ACS-2 PUIS Update to Power Management States

January 30, 2009

Revision 1

[Power management state diagram

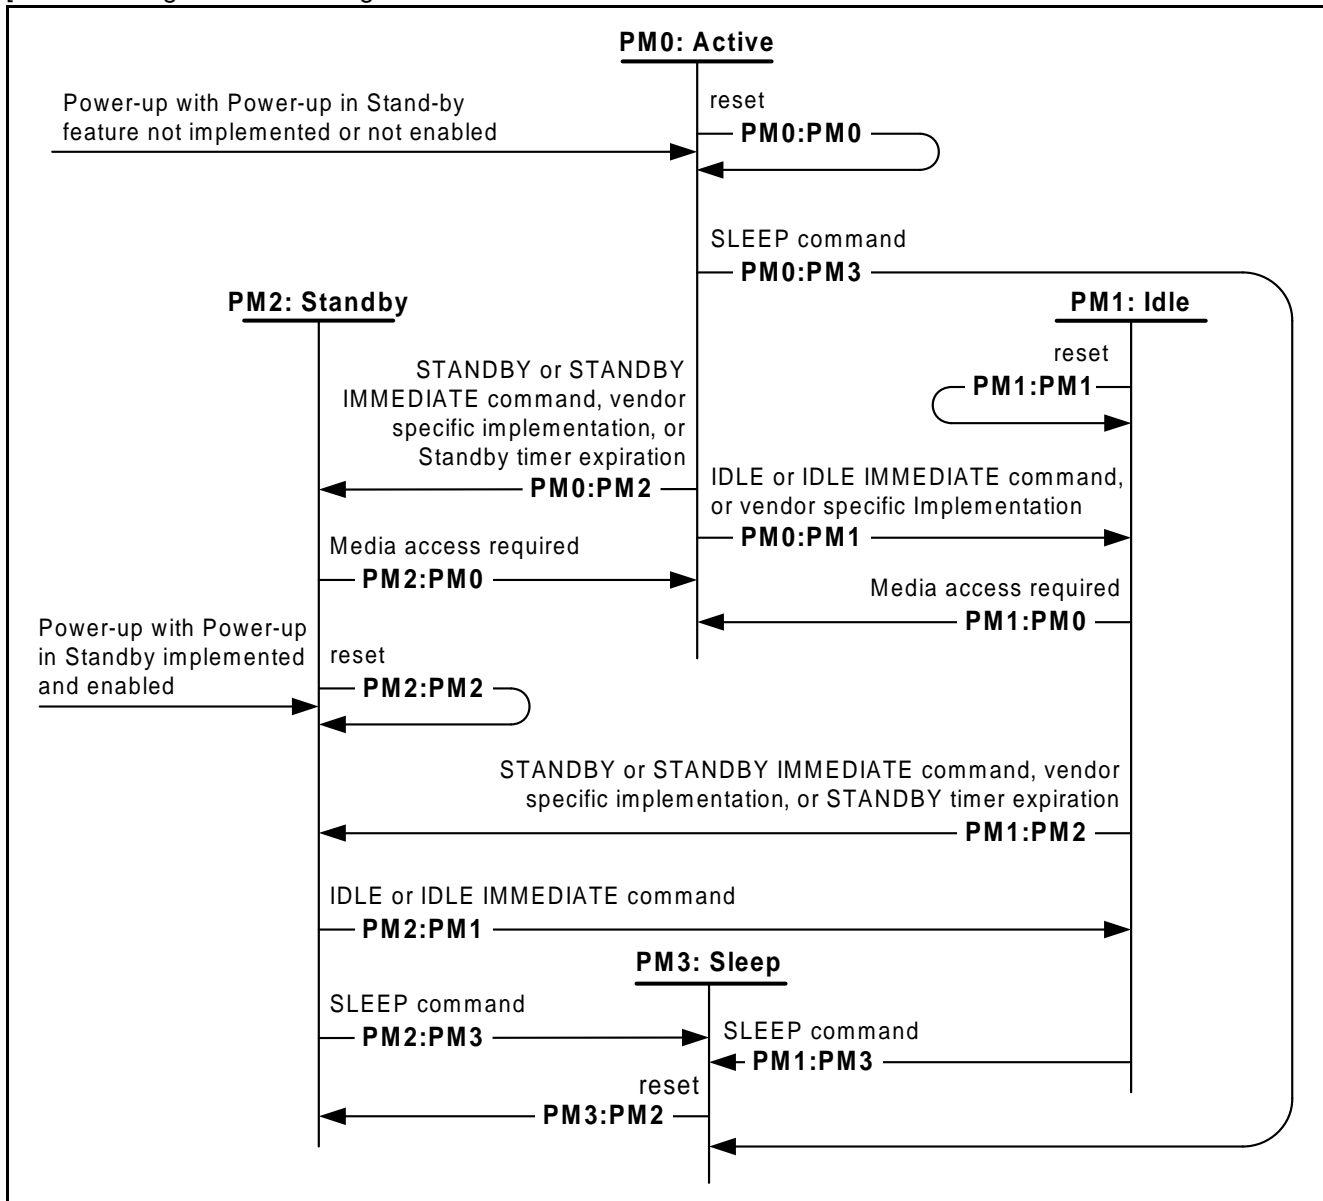
[Editors note: Update the diagram to reflect the new material](#)
